DART SERVICE INSTRUCTION

TO AMEND IIN-D412-704 REV. C OR EARLIER

AND ICA-D412-704 REV. 4 OR EARLIER

A	NEW ISSUE (REF PAR	RF	12.05.07
REV.	DESCRIPTION	BY	DATE
DESIGN	RF	DART AEROSPACE LTD	
DRAWN	RF	HAWKESBURY, ONTARIO, CANADA	
CHECKED		DRAWING NO.	REV. A
MFG. APPR.	N/A	DSI 9611	SHEET 1 OF 2
APPROVED		TITLE	SCALE
DE APPR.		PART NUMBER CORRECTION NTS	
DATE	12.05.07	COPYRIGHT © 2012 BY DART AEROSPACE LTD THIS DOCUMENT IS PRIVATE AND CONFIDENTIAL AND IS SUPPLIED ON THE EXPRESS CONDITION THAT IT IS NOT TO BE USED FOR ANY PURPOSE OR COPIED OR COMMUNICATED TO ANY OTHER PERSON WITHOUT WRITTEN PERMISSION FROM DART AEROSPACE LTD.

FIGURE 5 – Detail L.

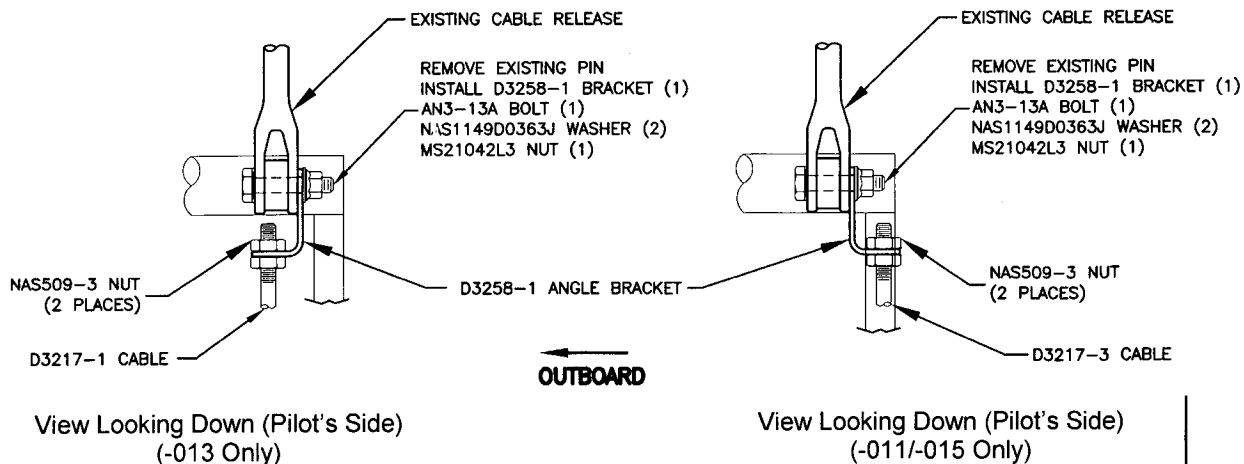
The purpose of this Dart Service Instruction is to correct part number error in Installations Instruction IIN-D412-704 Rev. C or earlier and Instructions for Continued Airworthiness ICA-D412-704 Rev. 4 or earlier. The AN3-13A bolt should be replaced with an AN3-10A bolt in Figure 5 - Detail L in IIN-D412-704 and Figure 25-4 Detail L in ICA-D412-704. See sheet 2.

Figure 5 - Detail L or Figure 25-4 - Detail L

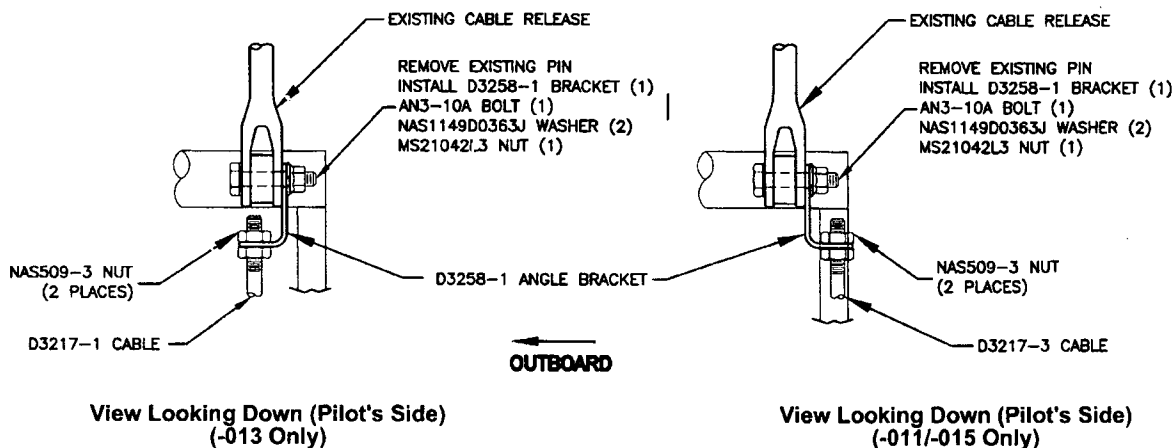
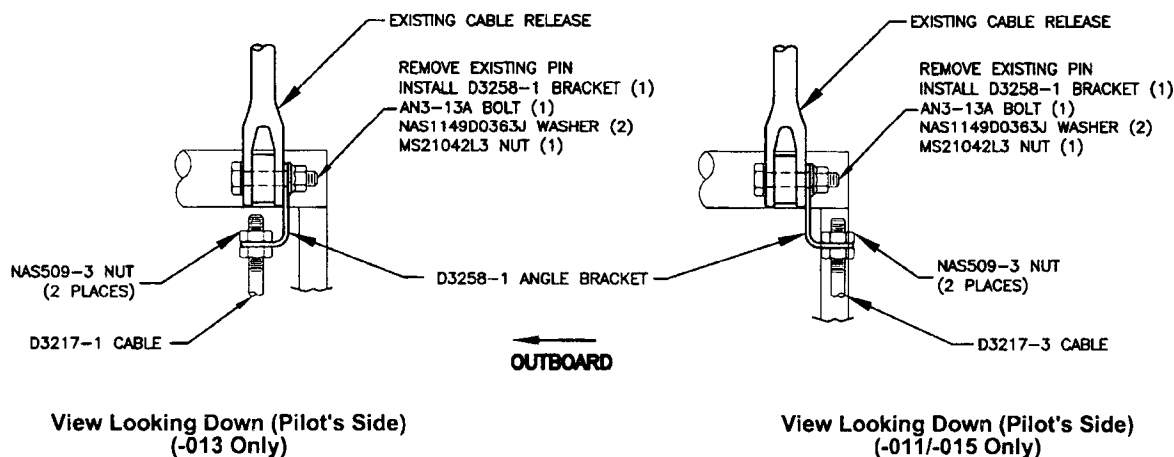
Revise Detail L Figure 5 of IIN-D412-704 and Detail L Figure 25-4 of ICA-D412-704 as follows:

NOW

WAS
